# Metropolitan Planning Commission

## Staff Reports

**March 26, 2009**

**Project No.** Zone Change 2009SP-002-001  
**Project Name** Primrose School SP  
**Council Districts** 31 - Toler  
**School Districts** 2 - Brannon  
**Requested by** Stantec Consulting Services Inc., applicant, for Chi Wai Lee, owner  
**Deferral** *Deferred from the March 12, 2009, Planning Commission meeting*  
**Staff Reviewer** Bernards  
**Staff Recommendation** *Approve with conditions*

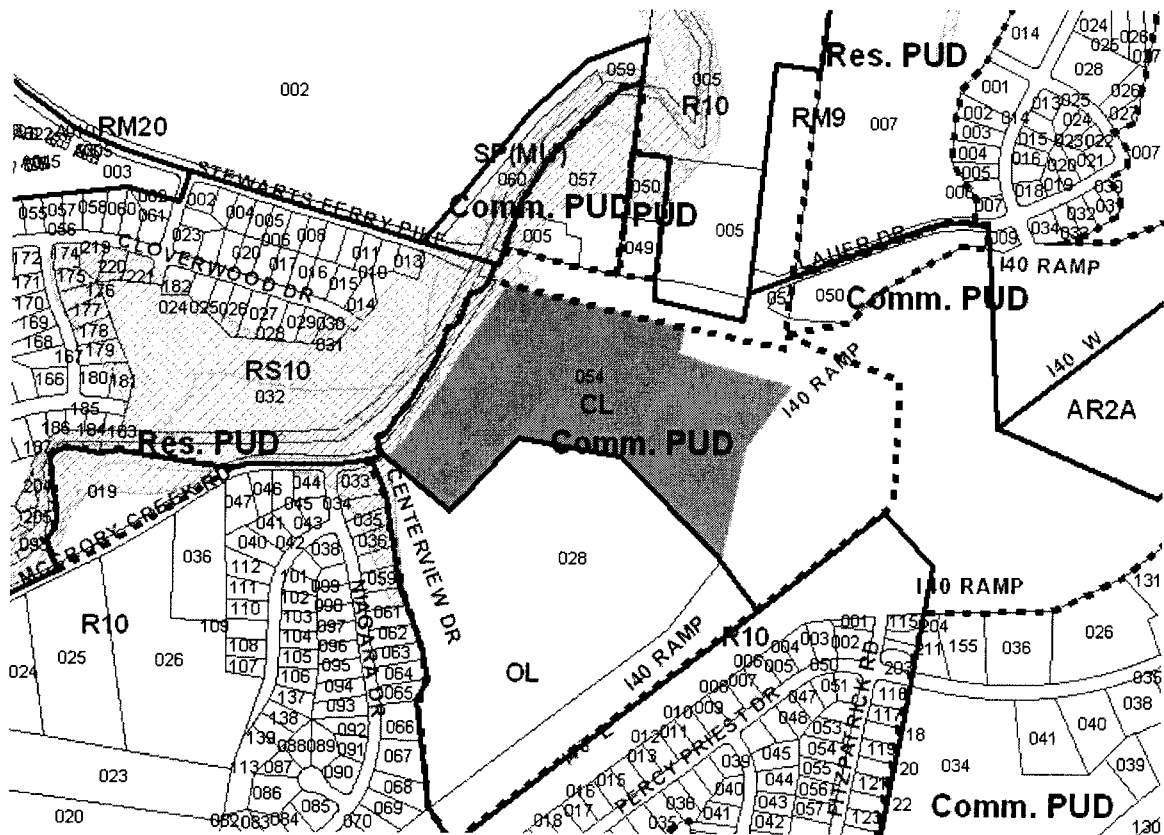
A ten-foot landscape buffer yard is proposed along the west, north and east sides of the property. Details have been provided on the plantings to be incorporated into the buffer. Backflow preventer devices are required for fire service, water service and landscape irrigation. These are located within the setback from Church Street East. Details of landscaping to screen these devices have not been provided. These details will need to be included on the corrected copies of the plan. Two outdoor play areas are included in the plan.

The original application included four housing units. These have been removed from the plan. All references to the housing must be removed from the corrected copies of the plans.

One access drive is proposed from Church Street East into the site. The usual requirement is to provide two access points in order to facilitate drop-off and pick-up of the children. The policy of the Primrose School is to require that all children be checked into and out of the office, which means that all parents/guardians must park and walk their child into the building. The applicant has provided traffic study and a parking needs assessment to the Public Works Department for their review.

Public Works determined that the original plan for vehicular circulation for the school was inadequate and that the applicant would need to better demonstrate that internal traffic flow at drop-off/pick-up area provides the same level of flow as two access points or additional on-site parking would be necessary. The applicant has amended the plan to include improved internal circulation and additional parking. The new

1. A copy of the Tennessee General Construction Permit NOC letter and the updating of the NPDES information on the plans will be required prior to scheduling the pre-construction meeting.
2. Plan Sheet C1.2 lists the vertical reference datum as NAVD-88. NGVD-29 is shown on the associated plan sheets.
3. Please add a note on the plans that all erosion control measures are to be removed prior to as-built approvals.
4. The Inspection and Maintenance Agreement document remains to be completed and notarized. This document will be added to the Long Term Maintenance Plan already submitted.
5. If this property will not be platted through the Metropolitan Planning Commission, then you must submit a completed Dedication of Easement document. The grading plan cannot be approved until the easement is reviewed and approved by MWS Property Services.

Show fire hydrant(s) flow data or the proposed fire hydrant(s) flow data on plans or the fire hydrant with the highest elevation and the most remote in the development,

Along Church Street E., construct a six (6') foot furnishing zone and eight (8') foot sidewalk, consistent with the Strategic Plan for Sidewalks & Bikeways.

1. Construct a westbound right turn lane on Church St. at the proposed project access with 75 ft of storage and transitions per AASHTO standards.
2. Construct the proposed project access at Church St. with one entering and two exiting lanes (LT and RT) each with a minimum 50 ft of storage.
3. Provide adequate intersection and stopping sight distance at the proposed project access per AASHTO standards.

1. Prior to the issuance of building permits, the two lots shall be consolidated by plat.
2. Details of the landscaped screening of the back flow preventer devices shall be provided on the corrected copy of the preliminary SP.
3. All references to the housing shall be removed from the corrected copies of the plans.

5. The requirements of the Public Works Department shall be addressed on the final site plan including:
  - a. Construct a westbound right turn lane on Church St. at the proposed project access with 75 ft of storage and transitions per AASHTO standards.

- b. Construct the proposed project access at Church St. with one entering and two exiting lanes (LT and RT) each with a minimum 50 ft of storage.
  - c. Provide adequate intersection and stopping sight distance at the proposed project access per AASHTO standards.

# Proposed Plan

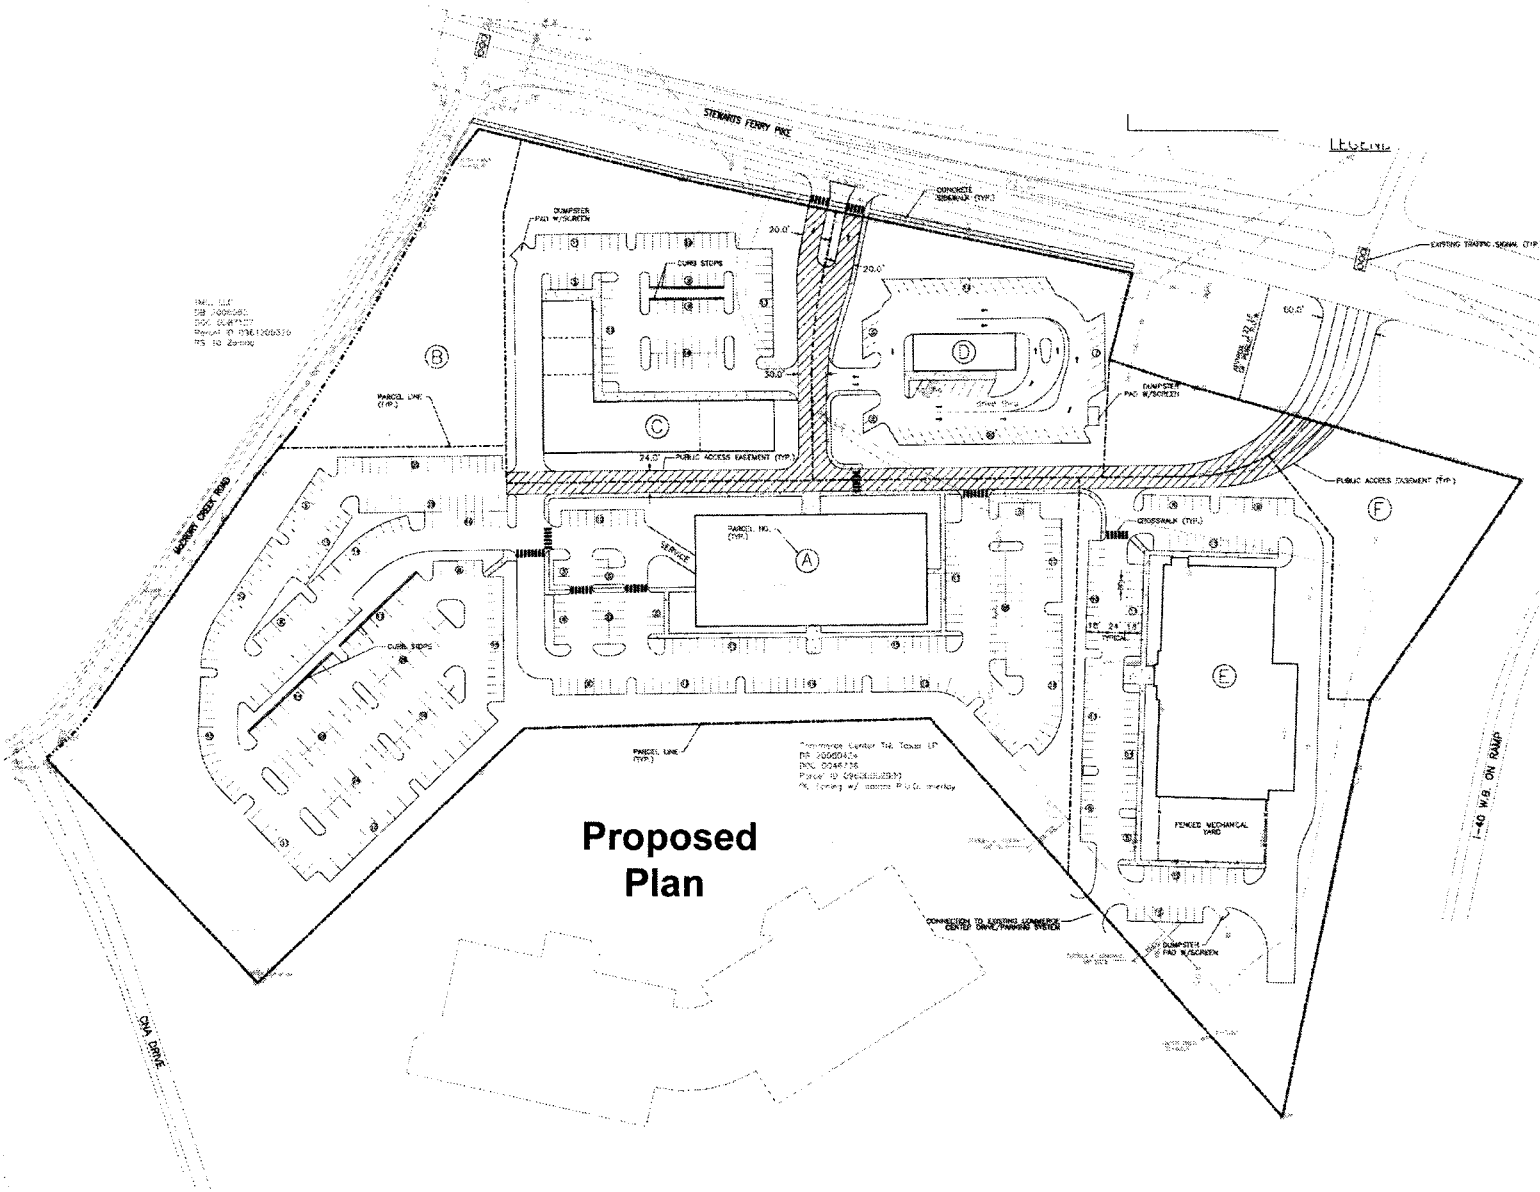
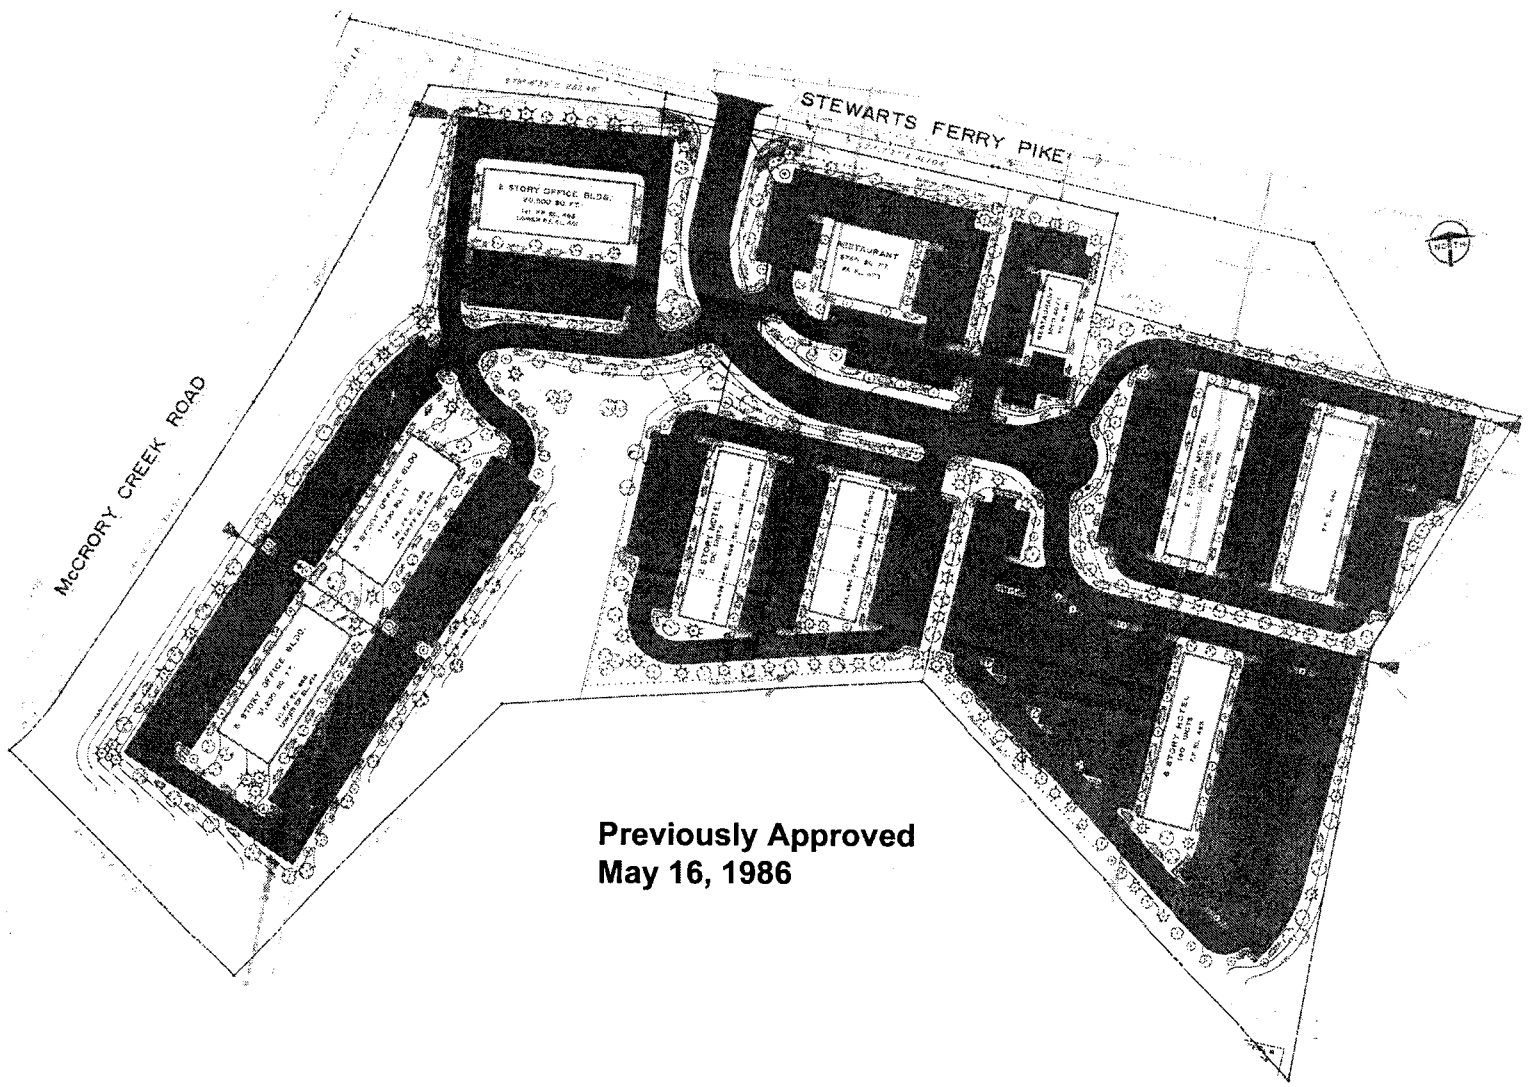
Access to the development is shown directly from Stewarts Ferry Pike and indirectly from McCrory Creek Road. The indirect access to McCrory Creek Road is shown from Centerview Drive which is a private drive and is located within the Larchwood PUD. A cross access easement will be required to ensure that the access can be legally maintained.

1. All Public Works' design standards shall be met prior to any final approvals and permit issuance. Any approval is subject to Public Works' approval of the construction plans.
2. Show and dimension right of way along Stewarts Ferry Pike. Label and show reserve strip for future right of way 42 feet from centerline to property boundary, consistent with the approved major street plan (U4 - 84' ROW).

3. Show and dimension right of way along McCrory Creek Road at property corners. Label and dedicate right of way, 30 feet from centerline to property boundary, consistent with the approved major street / collector plan.
4. Right of way is required along McCrory Creek Road for the construction of the McCrory Creek Business Park required infrastructure improvements. Coordinate the proposed site development with the McCrory Creek Business Park development. Dedicate right of way, grade site, and located the proposed retaining wall outside of the required improvement areas.
5. For the proposed sidewalk construction along Stewarts Ferry Pike, construct a six (6') foot furnishing zone and eight (8') foot sidewalk, consistent with the Strategic Plan for Sidewalks & Bikeways.
6. A Traffic Impact Study is under review and comments will be forthcoming.

1. Remove detention / water quality pond out of the zone 2 stream buffer.

1. Prior to any final site plan approval, the applicant must demonstrate that the development can legally access McCrory Creek Road through parcel 028. Access shall be provided by a cross-access easement which shall be platted or recorded by instrument.
2. Remove detention / water quality pond out of the zone 2 stream buffer.
3. Prior to the issuance of any building permits, a final plat shall be required, including the dedication of right-of-way along McCrory Creek

# Conceptual Drawing

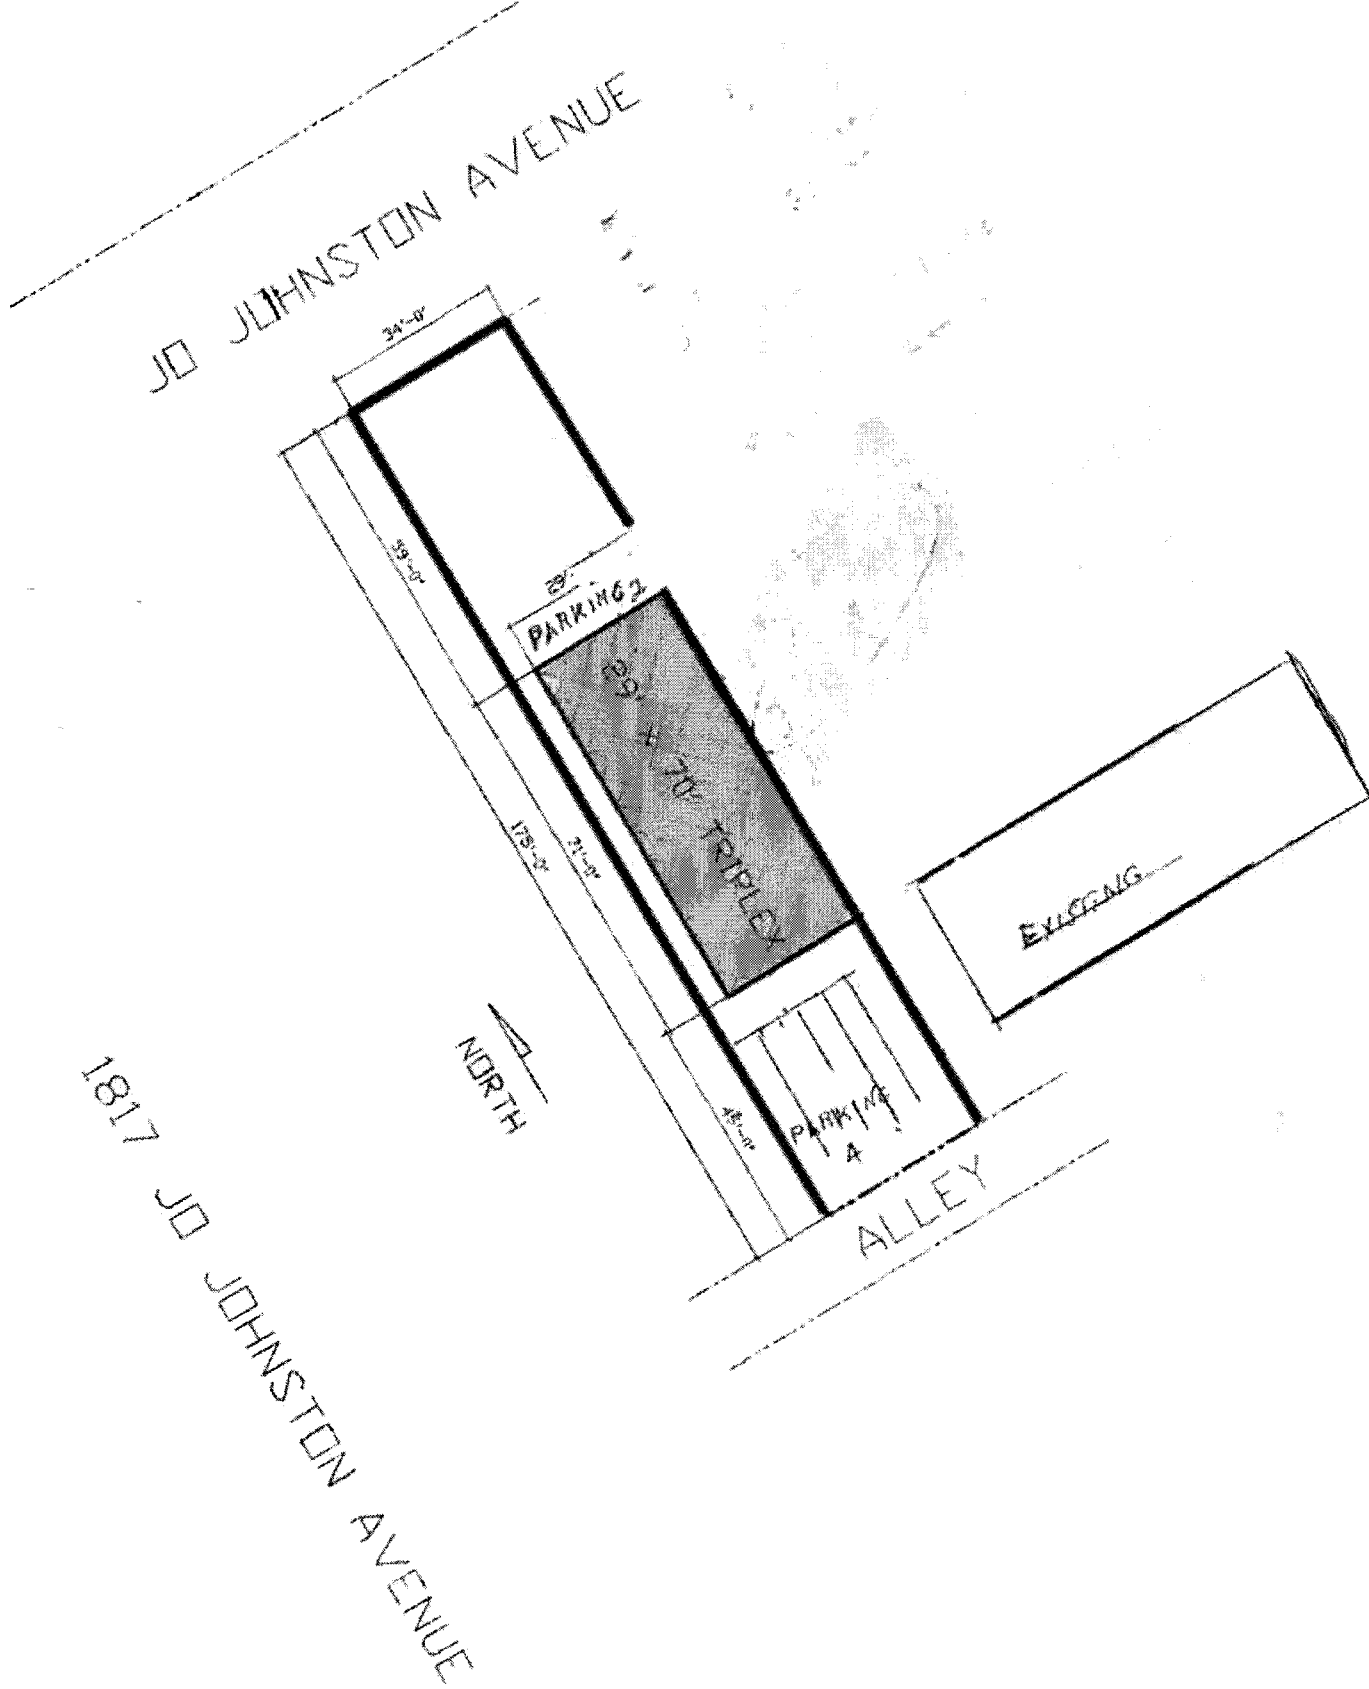
While an enforceable site plan was not submitted with this zone change, staff is recommending that a condition be added to this request to require access to the site be from the alley at the rear of the property. This condition will address the guidelines of the Watkins Park DNDP to enhance the pedestrian environment by limiting additional access to Jo Johnston Avenue.

The applicant did submit a conceptual drawing. The conceptual drawing shows a 2,030 square foot triplex building with six parking spaces. Two of the spaces appear to be accessed from Jo Johnston Avenue and the remaining four from the alley to the rear. As noted above, staff is recommending that all parking be accessed from the alley.

conceptual drawing does not appear to have sufficient area on the east side to accommodate the setback. As this is the side adjacent to the property under the same ownership, combining the lots would resolve this. A standard B Buffer would be required along the western property line in order to provide additional buffering for the existing R6 property.

1. Access to the parcel included in this zone change shall be limited to the alley to the rear of the parcel only.
